## ADDENDUM

Reference: Utah National Guard – Ogden Armory  
Roofing, Mechanical, Electrical, and Window Improvements  
DFCM Project No. 05040470

Subject: **Addendum No. 1**

## ELECTRICAL ADDENDUM ITEMS

## LOWER LEVEL ELECTRICAL PLAN

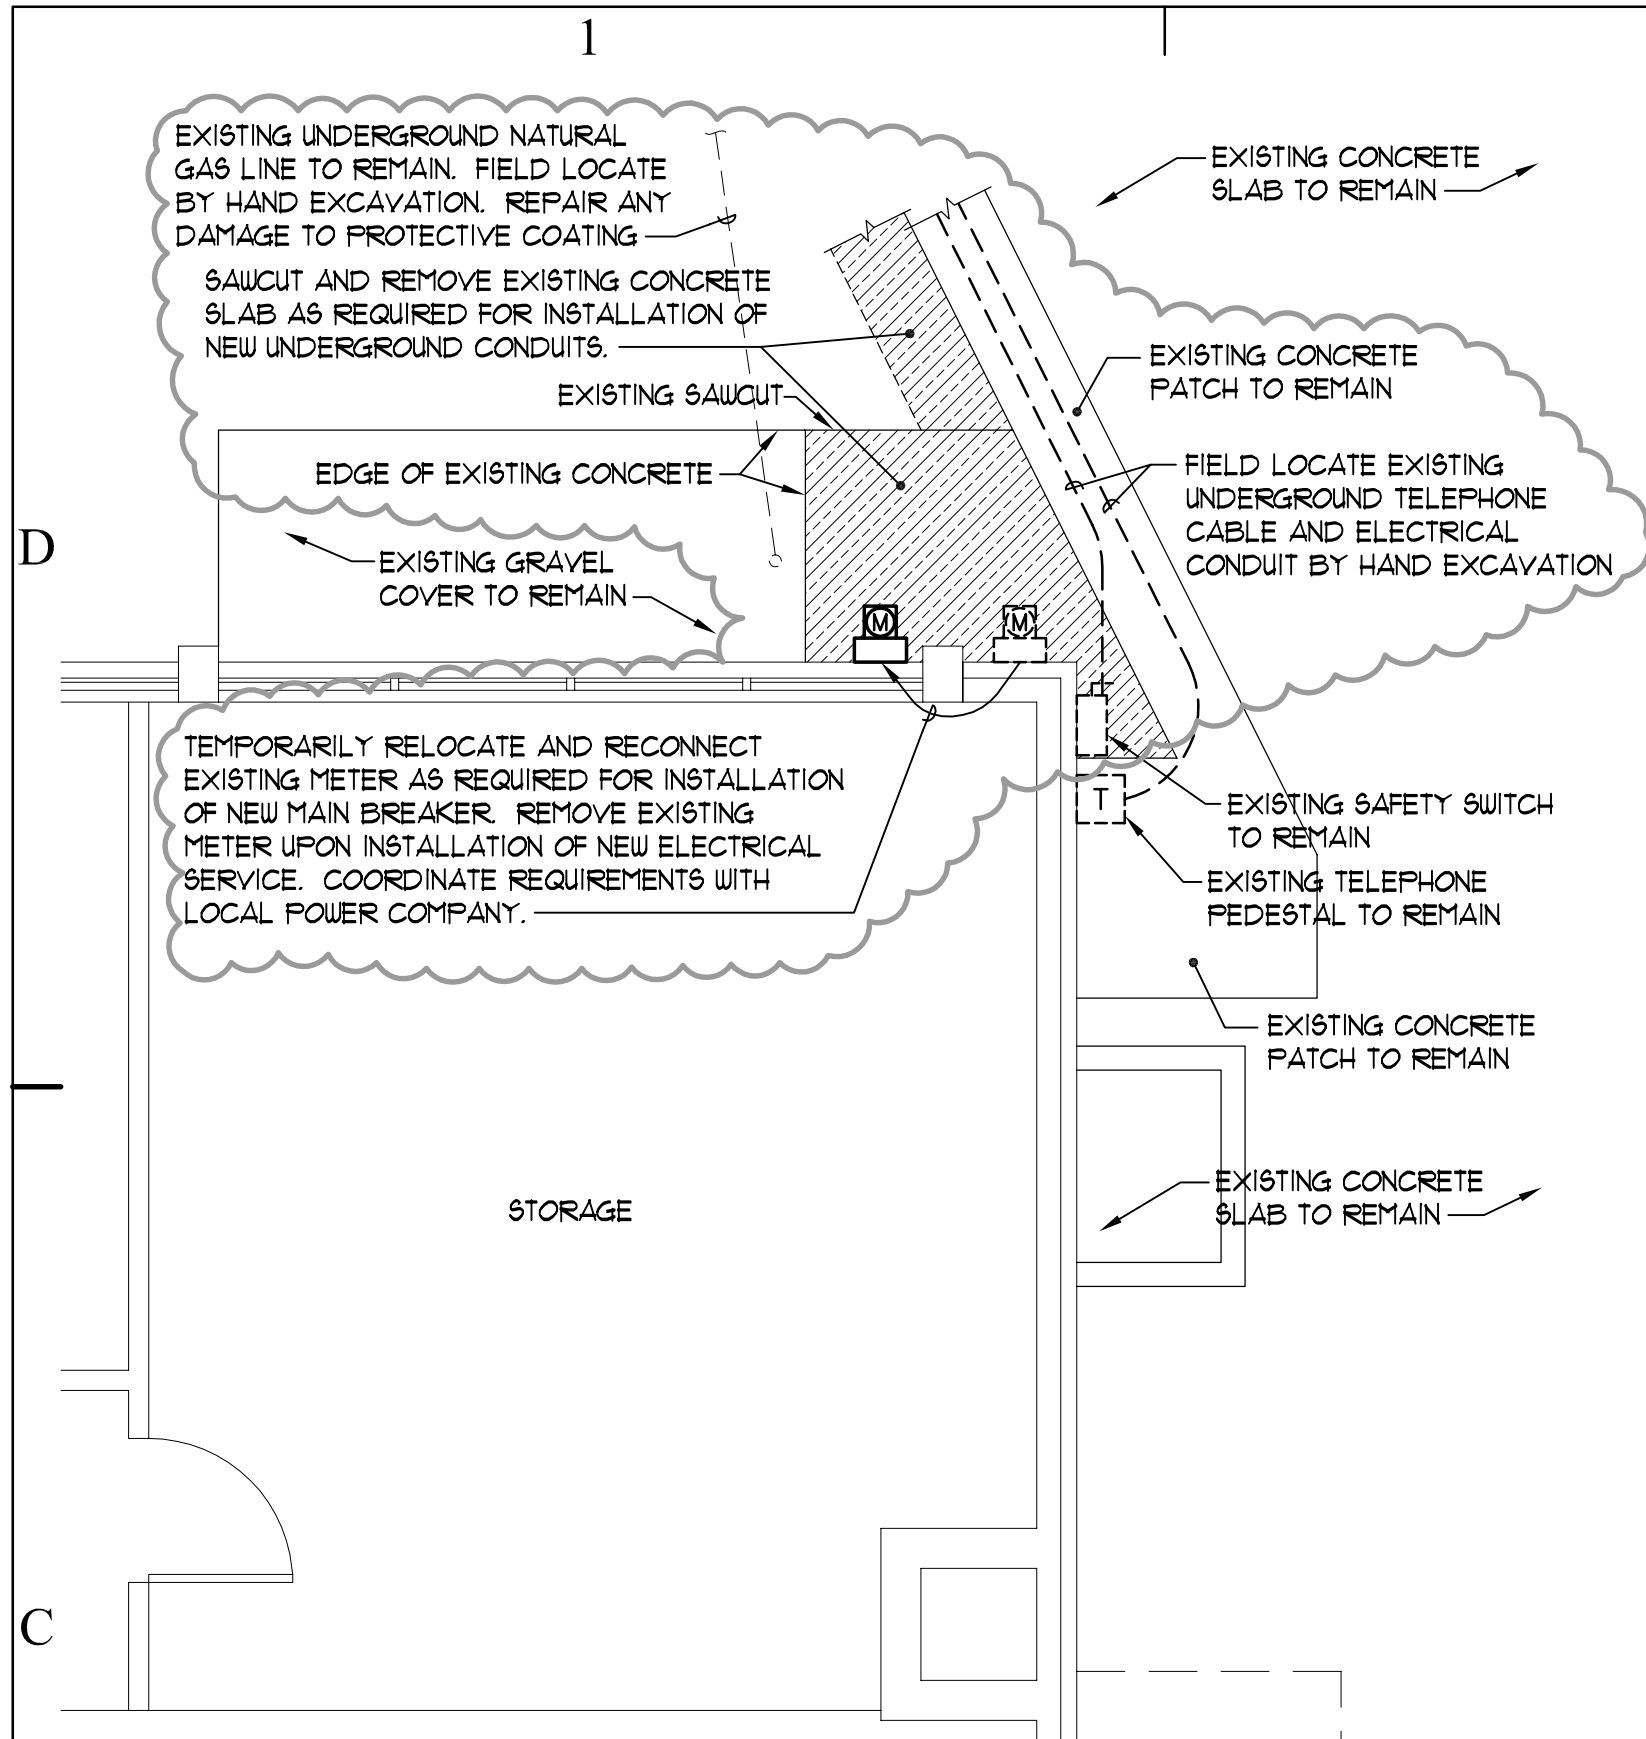
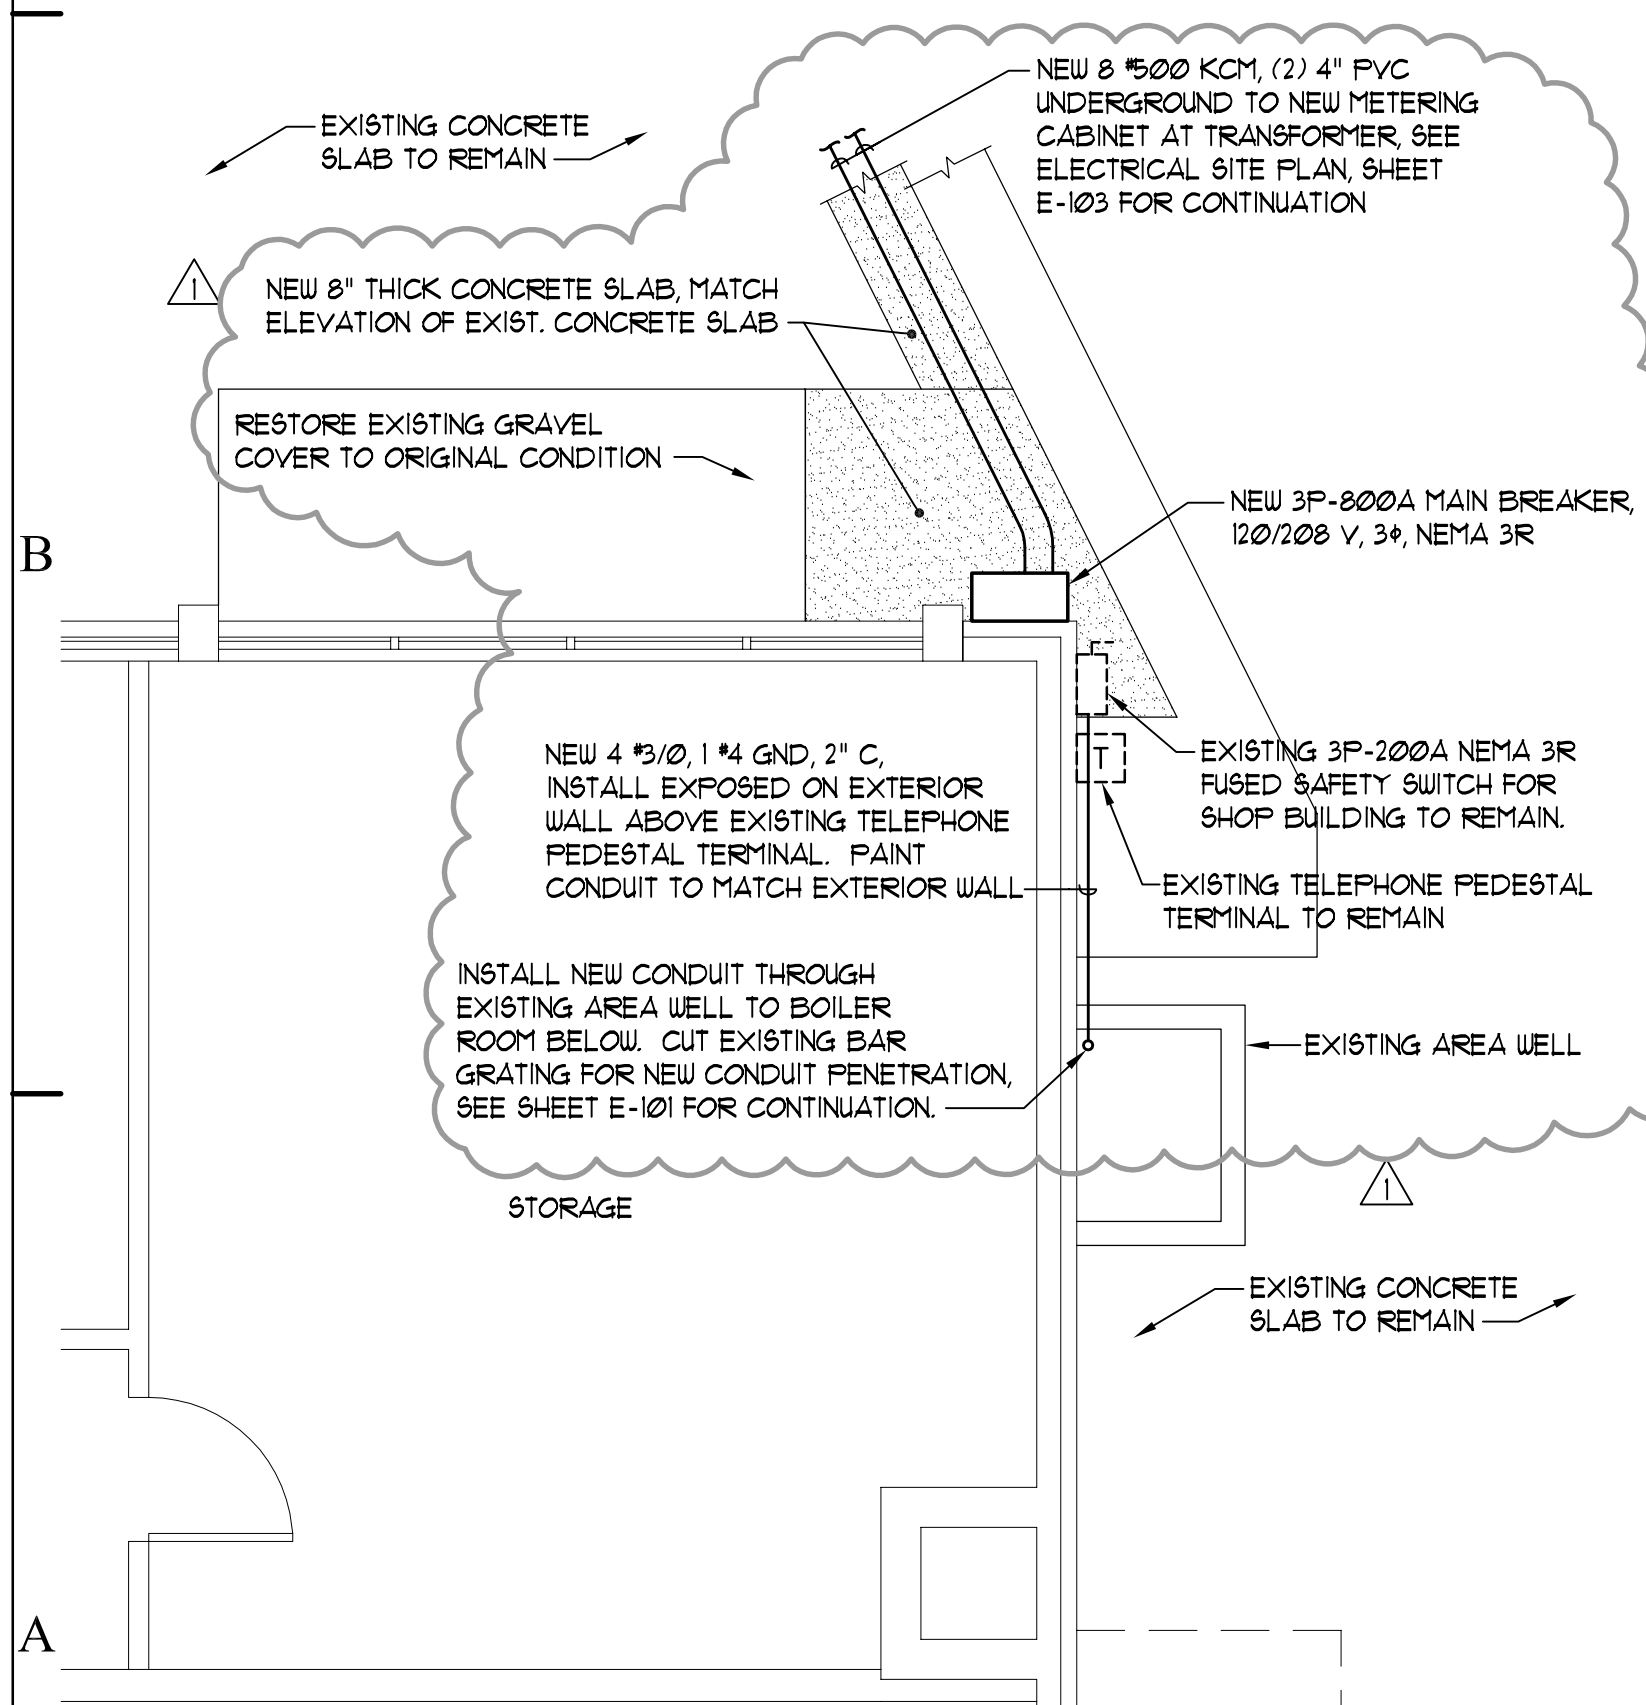
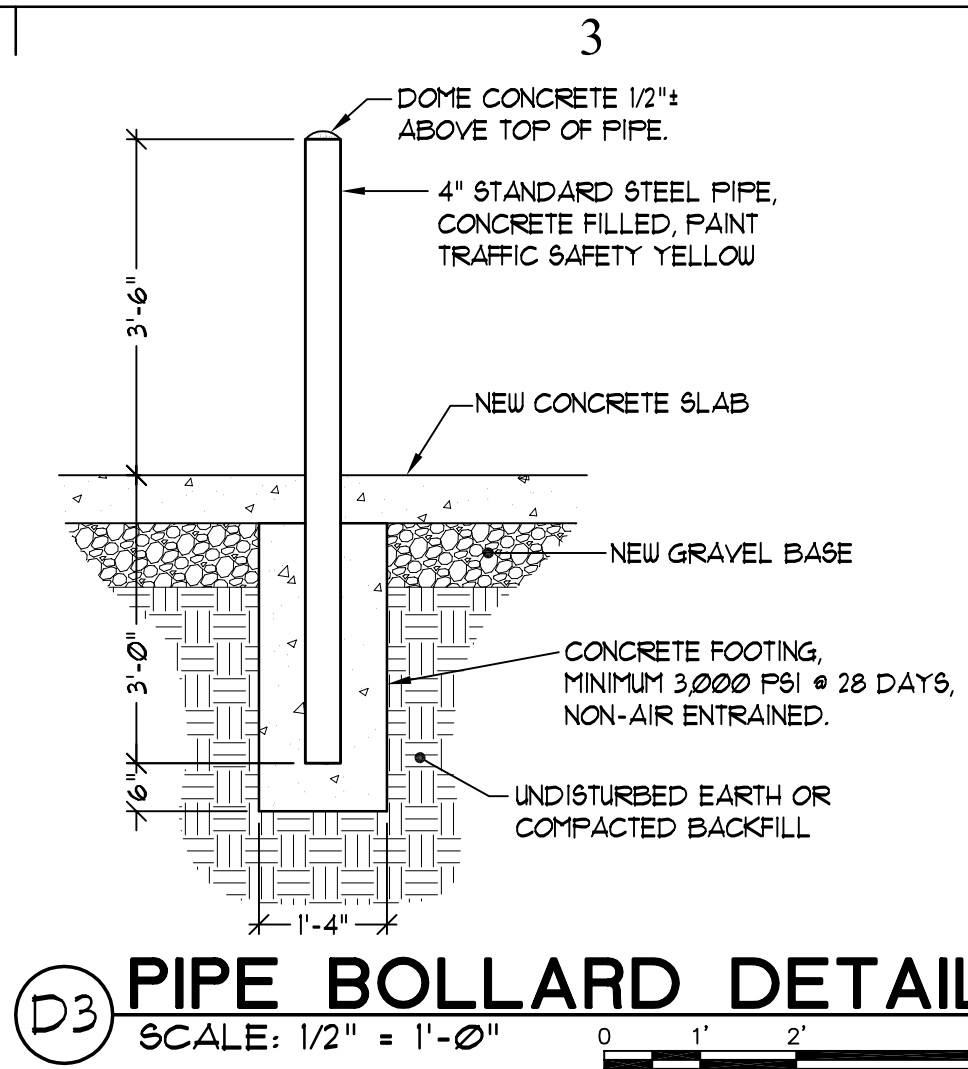
1 PANEL 'BR' SCHEDULE MOVED FROM SHEET E-601, NO CHANGE TO SCHEDULE.

16 NEW 3/4" x 10'-0" COPPER GROUND RODS. PROVIDE #3/0 BARE COPPER GROUND CONDUCTOR IN 1-1/2" PVC CONDUIT SLEEVE TO NEW MAIN BREAKER GROUND BUS.

**FIRST FLOOR  
ELECTRICAL PLAN**

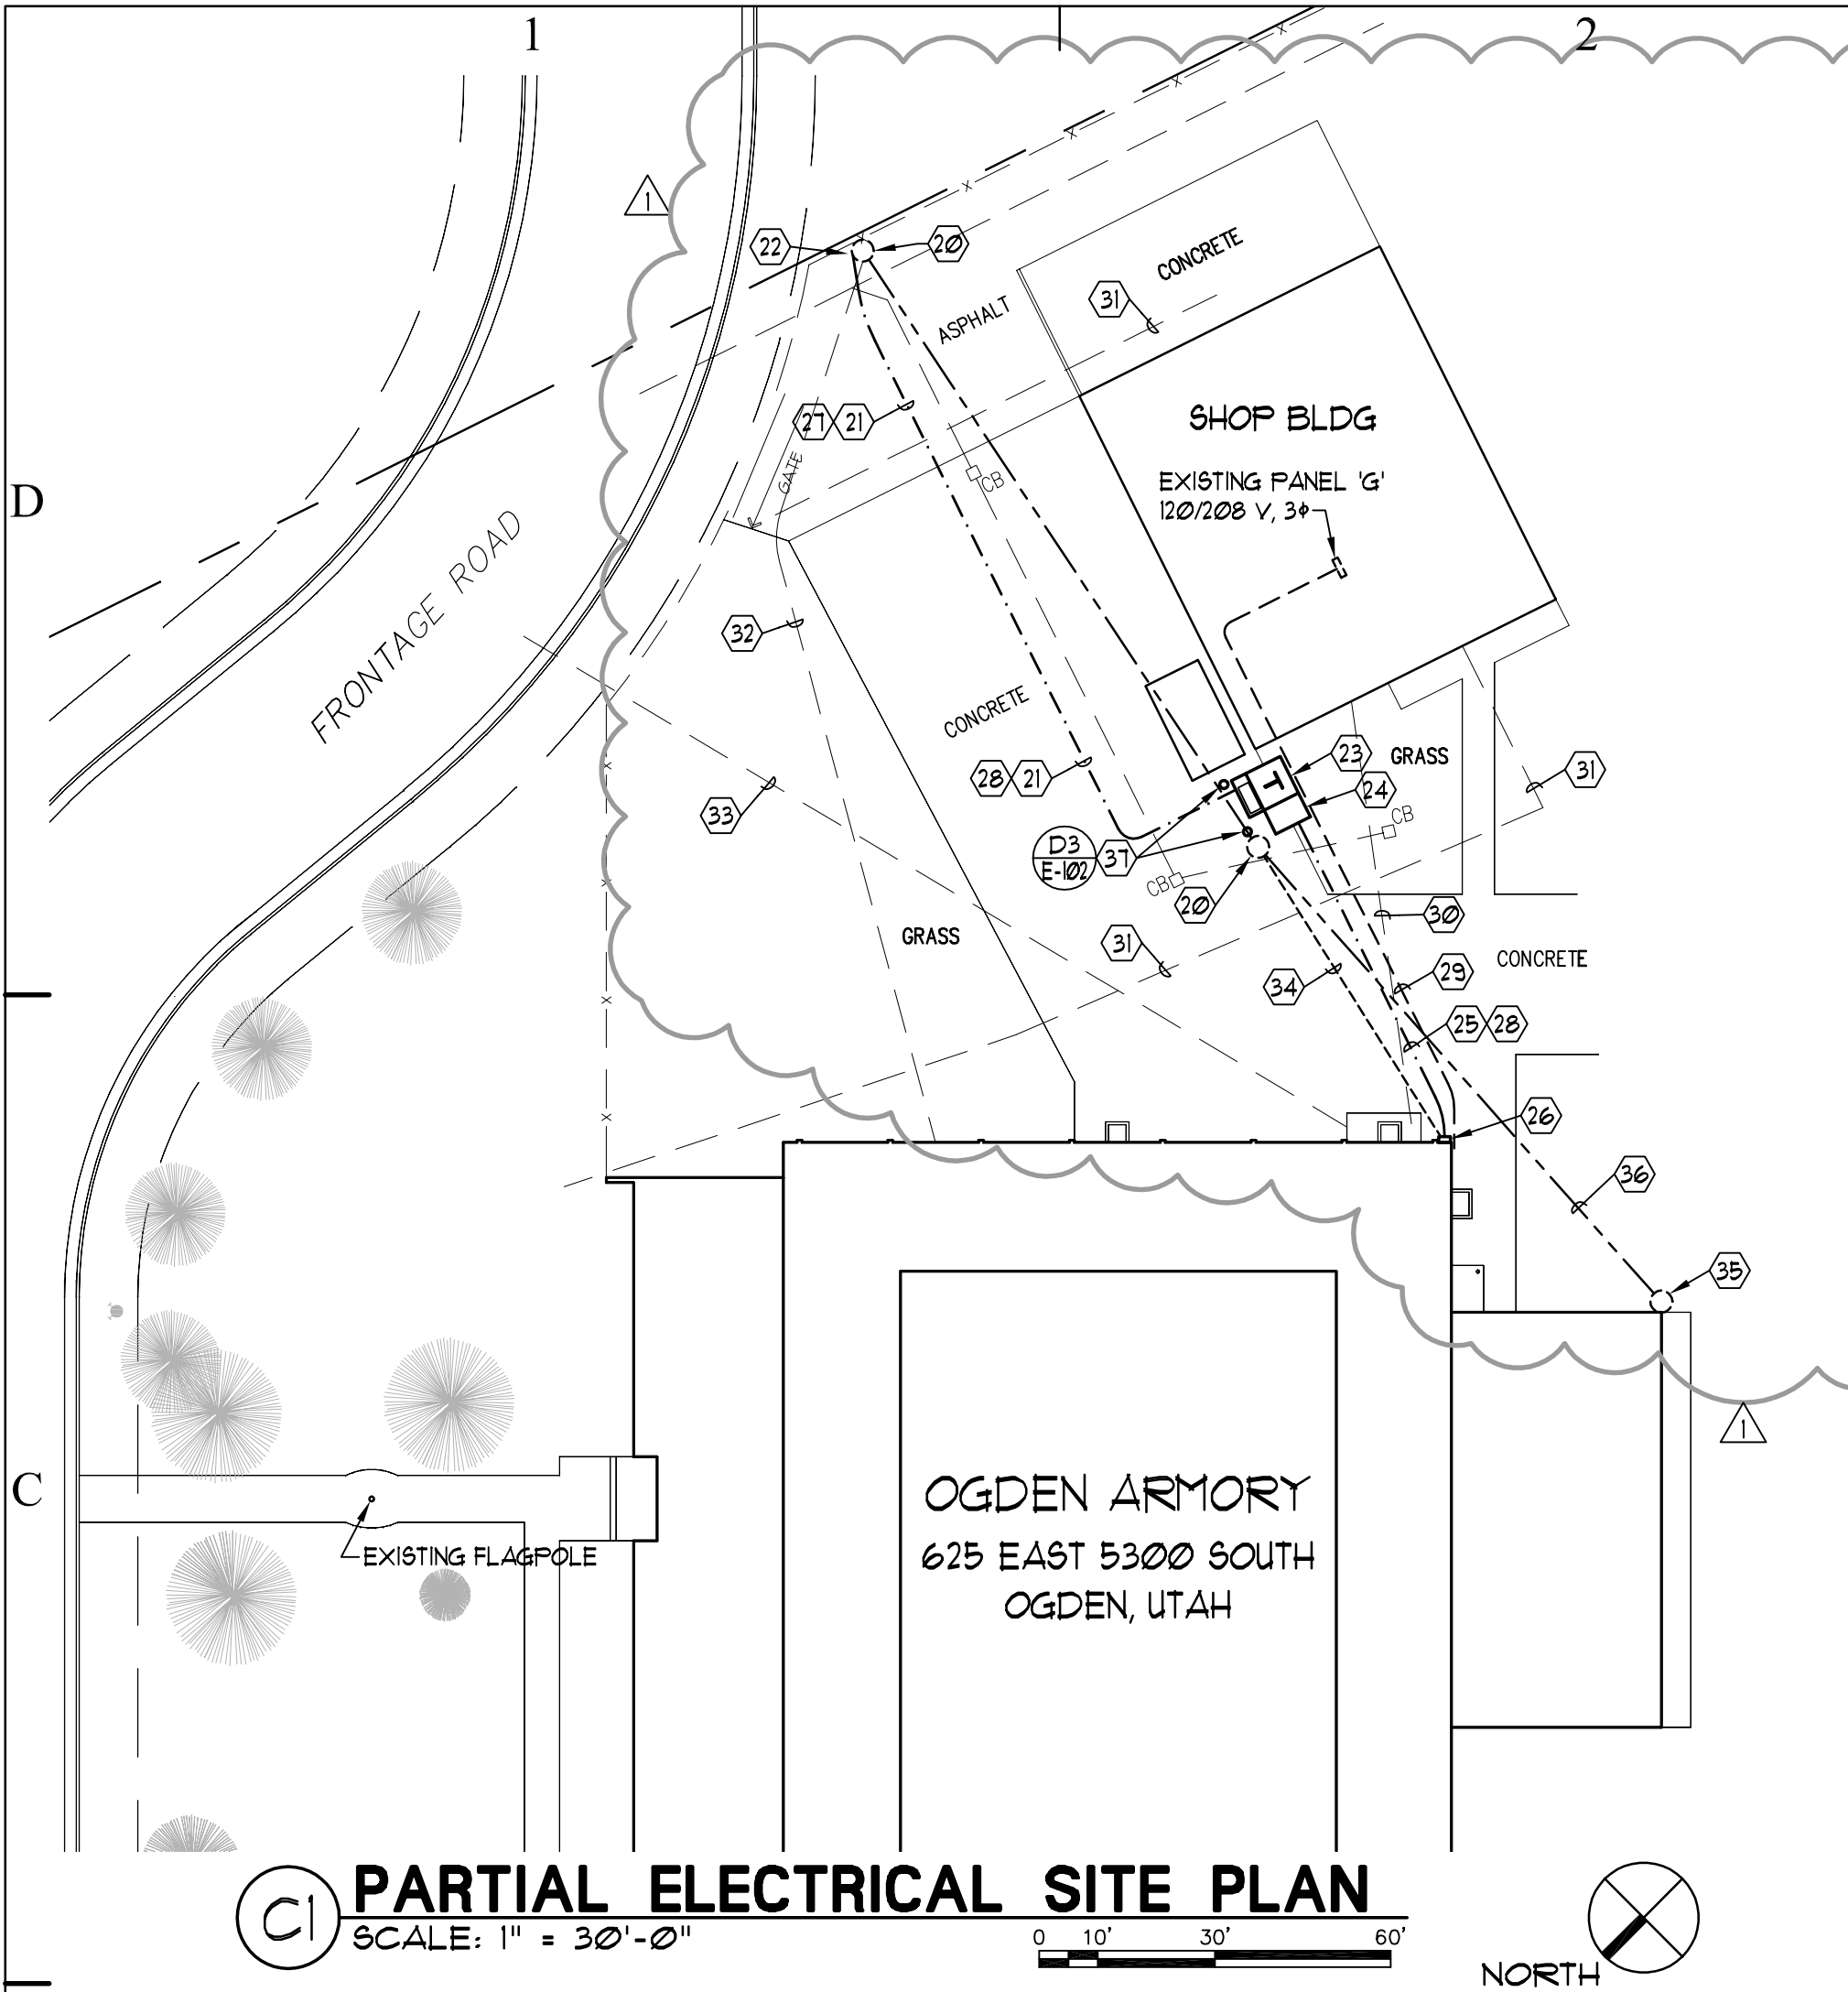
2. Change Conduit Routing to Rooftop AC Units RTU-1 and RTU-2.
  - A. Change conduit routing to Rooftop AC Unit RTU-1 and RTU-2 to avoid installation of exposed conduit in the Main Entry Vestibule. See First Floor Electrical Plan, Sheet E-102, Revision No. 1.
